TMC SPECIFICATION

NO. S 1035

MODIFICATION PROCEDURE FOR THE KIT-234

To convert the AFC-3 to the AFRC-3.

TOP VIEW FIGURE 2

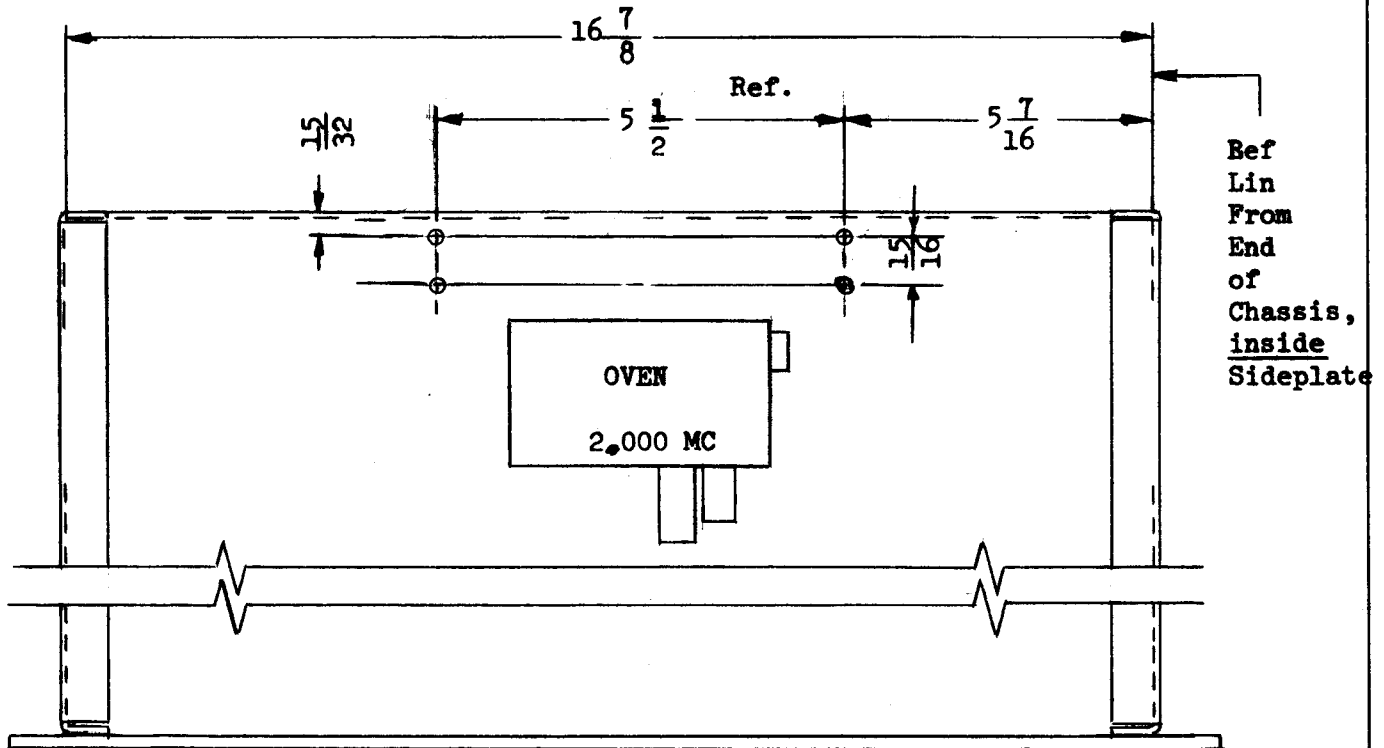
- 8) Locate and drill 4-1/8 holes for A5003 connector/ray assembly item 1 using item 17. (SEE Figure 2)

FIGURE 3

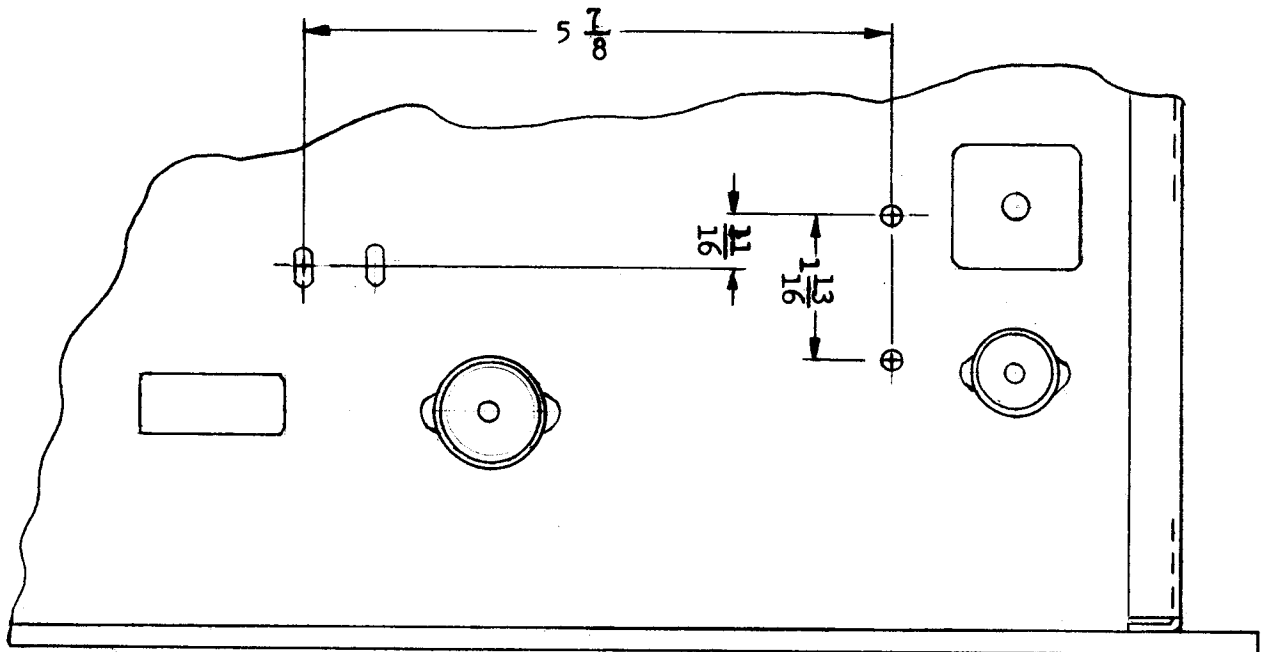
- 9) Mount item (1) using items 6, 7, and 8.
- 10) Locate and drill 2-11/64 holes using item (18) for item (2) (gear box assembly). SEE Figure 3.
- 11) Mount item (2) using items 9, 10, 11 and 4. SEE Figure 5.
Dress cable as shown.

FRONT PANEL REARVIEW FIGURE 4

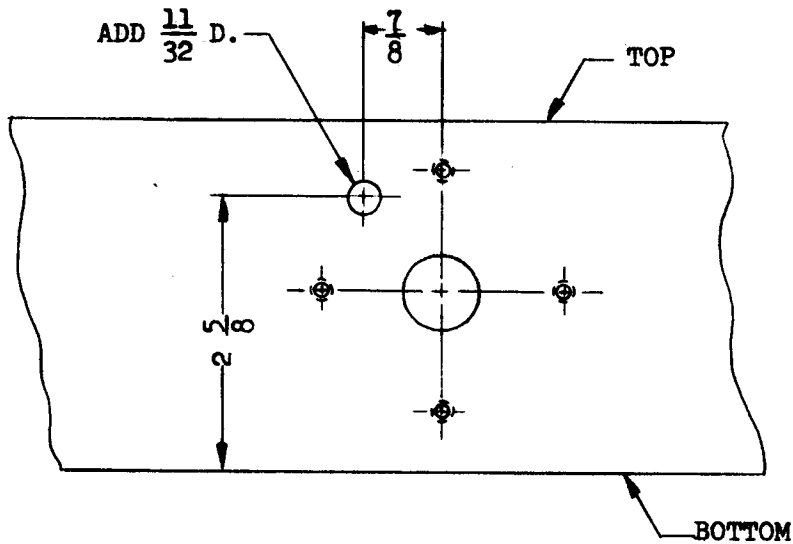
- 12) Connect shaft to shaft coupling to oscillator. Do not tighten shaft coupling at this time. (SEE Figure 5)
- 13) Locate and drill (using item (19) an 11/32" drill) hole for item (3) (Gear reduction assembly) on front panel. SEE Figure 4.
